ENVIRONMENTAL REVIEW TEAM REPORT
ON THE
PROPOSED REGIONAL HIGH SCHOOL
HADDAM, CONNECTICUT

MAY 1974

EASTERN CONNECTICUT RESOURCE CONSERVATION
AND DEVELOPMENT PROJECT
Environmental Review Team
139 Boswell Avenue
Norwich, Connecticut 06360

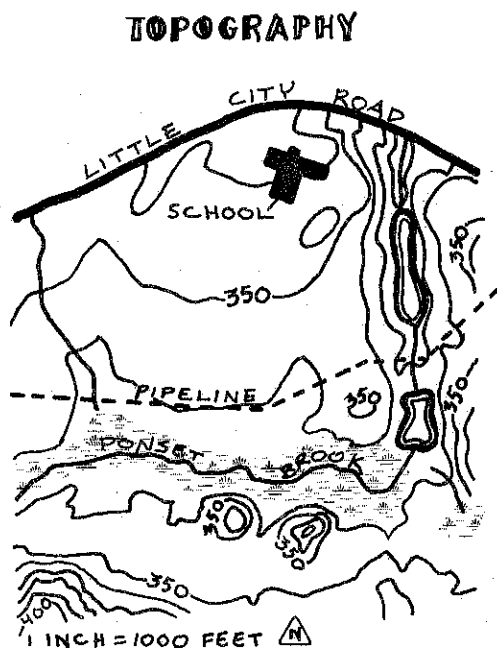
Description. The topography map below shows the location of the existing Junior High School in relation to the Ponset Brook. The major wetland area lies to the south of the buried telephone right-of-way (pipeline). The proposed school buildings will be located directly south of the existing buildings, with the recreational facilities further south. As mentioned before, the three most southerly athletic fields would encroach upon the wetland and require a relocation of Ponset Brook. The south end of the proposed football field also encroaches upon a wetland area, but not as extensively.

The plan as proposed calls for the clearing and filling of about 5 acres of wetlands and the rerouting of 250 to 300 feet of Ponset Brook. Approximately 30 to 60 percent of the width of the local wetland area would be filled and turned into dry land. However, the area of impact would extend beyond the edge of the filled land.

Hydrologic Effect. The existing flood plain of Ponset Brook in the area of the proposed filling is about 450 feet wide. This land floods frequently during periods of high runoff throughout the spring and fall. Rerouting the brook to a channel with a bottom width of 12 feet and a 2:1 side slope would greatly restrict the flow of water through the existing swamp. The water will reach a higher stage in the new channel than would be expected in the swamp.

From this it is estimated that standing water levels in the middle of the baseball field, which is the location for the proposed leaching fields, are at or above 81.5 feet. This will tend to rise slightly to the north under home-plate of the proposed ball field. The site plan shows the elevation of the leaching pipes to be in the range of 82.5 to 83.5 feet. Under the present water

conditions, this leaves one to two feet between the leaching pipes and existing ground water levels. The distance between the leaching trenches and ground water would be even less and might possibly intersect.

Proposed site alterations would appear to aggravate this situation by raising the ground water. These changes include restriction of water movement through the new stream channel, reduction of water loss by evapotranspiration, addition of five feet of fill in the area of the leaching field, and discharge of large amounts of water into the ground tending to mound the water table. Also to be considered is that this has been a fairly normal spring and that in wetter years the seasonal rise in the water table would be greater.

The proposed system appears to be designed at or below minimum standards, assuming that the ground water levels will never be any higher than at present. The design severely limits the probability of effective renovation of wastes in the unsaturated soil zone, and if the water table should rise much, the system may be prone to actual failure.

It is recommended that the plans for waste disposal be reviewed to allow for higher water tables. A placement of pipes at 85.5 feet would allow 18 inches for gravel, 18 inches to groundwater, and a 12 inch margin for "wet" years and/or ground water buildup. From the above observations and evaluations, this would be the minimum desired. The effective operation of these leaching fields will be of particular importance in maintaining the quality of Ponset Brook.
